Delmore Fast-Track

25/06/2025 – Auckland Council Response

Technical Specialist Memo – Parks and Community Facilities

Applicant's Name:	Vineway Limited (Applicant)
Application number:	BUN60444768
Activity type:	Subdivision and development
Site address:	88, 130, 132 Upper Orewa Road and 53A, 53B and 55 Russell Road, Orewa

Figure 1: Provision assessment by Council's Property Provision Team.

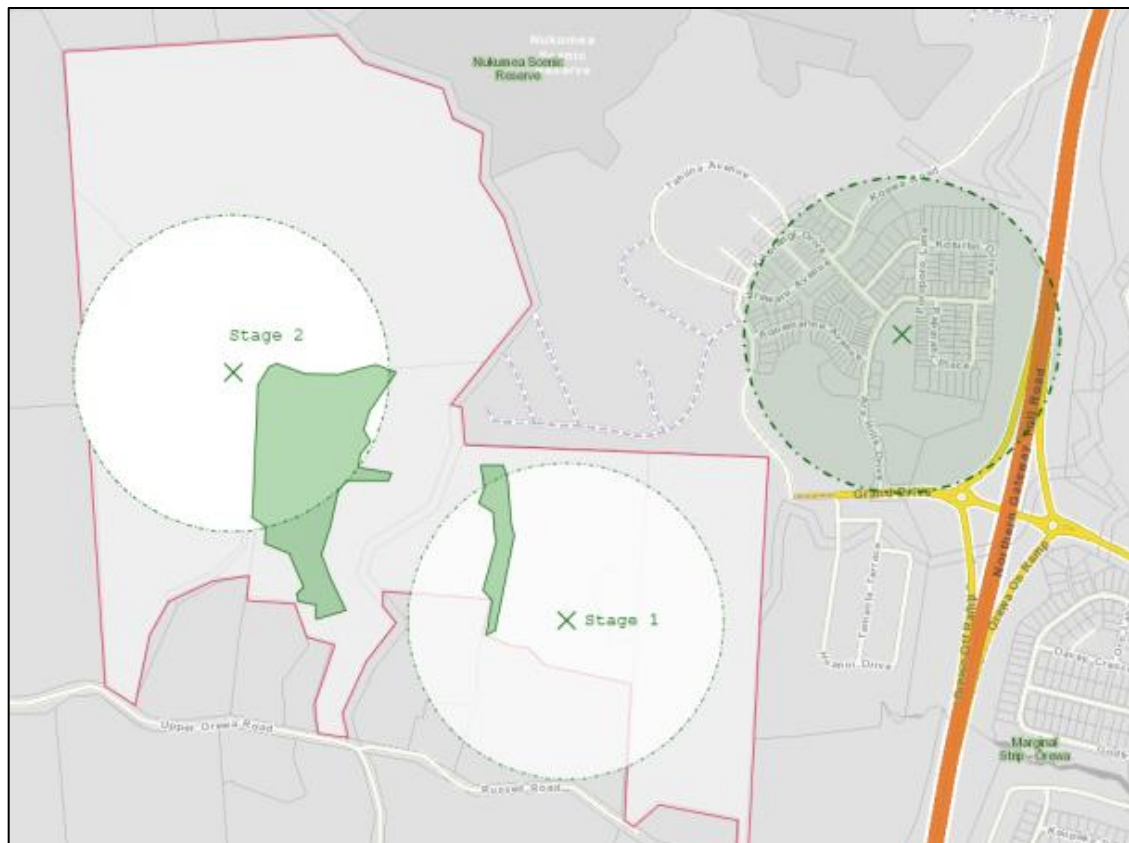
- 4.3 There is a general willingness to support the provision of these two neighbourhood park locations subject to key metric confirmations with a radial based assessment of a 300m circle applied to the provision targets as per figure 1 above and Table 1 below.

Figure 2: Stage 2 Neighbourhood Park Scheme plan.
Source: *Park Reserve contours, Dwg 3725-2CDE-2006*.

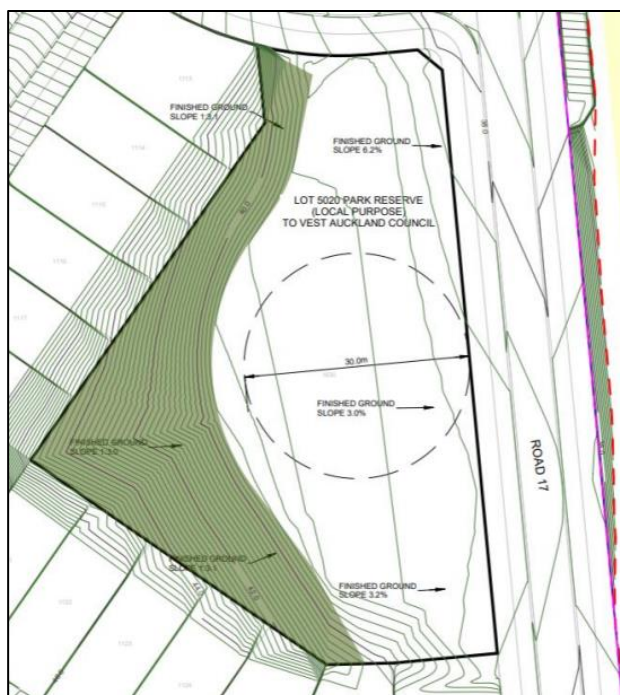
- The Applicant has been responsive in identifying the need for two neighbourhood parks to support the development and have agreed to the density discussions under table 1 of the Open Space Provision Policy (2016).
- There are key concerns with the quality of the land. The Applicant has provided a topographical plan for the proposed stage 2 neighbourhood park (figure 2). The current design of the park has limited utility with the battering/topography to the western interface absorbing potential land. As the battered land is not functional from an open space lens, the proposed park from a function and utility of land perspective is not of a neighbourhood park function, but more of a pocket park.

- c. In the case of it being a pocket park, the asset will be required to vest at no capital cost. It is important to acknowledge that pocket parks are not preferred as with the intended density and scale of the development, neighbourhood parks are integral to ensure that the health of these future communities are provisioned accordingly.

- d. The current scheme and particularly topographical issues are not adequate to meet policy activations or future community needs. The stage 1 park was an addition under the RFI response by the Applicant. While from a provision lens an additional park is appropriately located, there is little to no detail in terms of site-specific measures.

Figure 3: Potential location of Stage 1 Park.

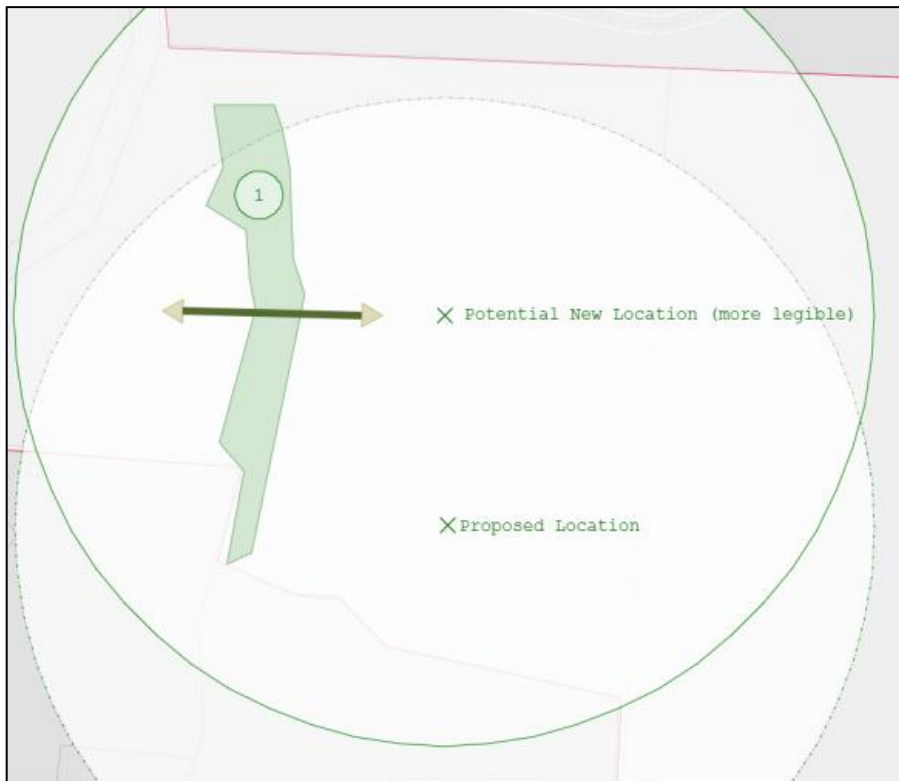
- 4.23 The scheme plans provided (Appendices 17-1 to 17-4) do not clearly indicate whether any relevant accessways are proposed to vest. Similarly, there is no reference to vesting in the documentation. Section 7.5 of the lodged AEE (Subdivision and Development Staging) does not mention any relevant accessways, and as such, no assessment has been undertaken by Parks Planning. All accessways and walkways appear to remain in private ownership.
- 4.24 From an activation perspective, the inclusion of alternative routes and informal connections is considered beneficial and is supported from a Parks Planning standpoint. There is extensive potential for the re-alignment of not only park locations but wider macro-path integration to enable for greater legibility as per Figure 3 below for Stage 1.
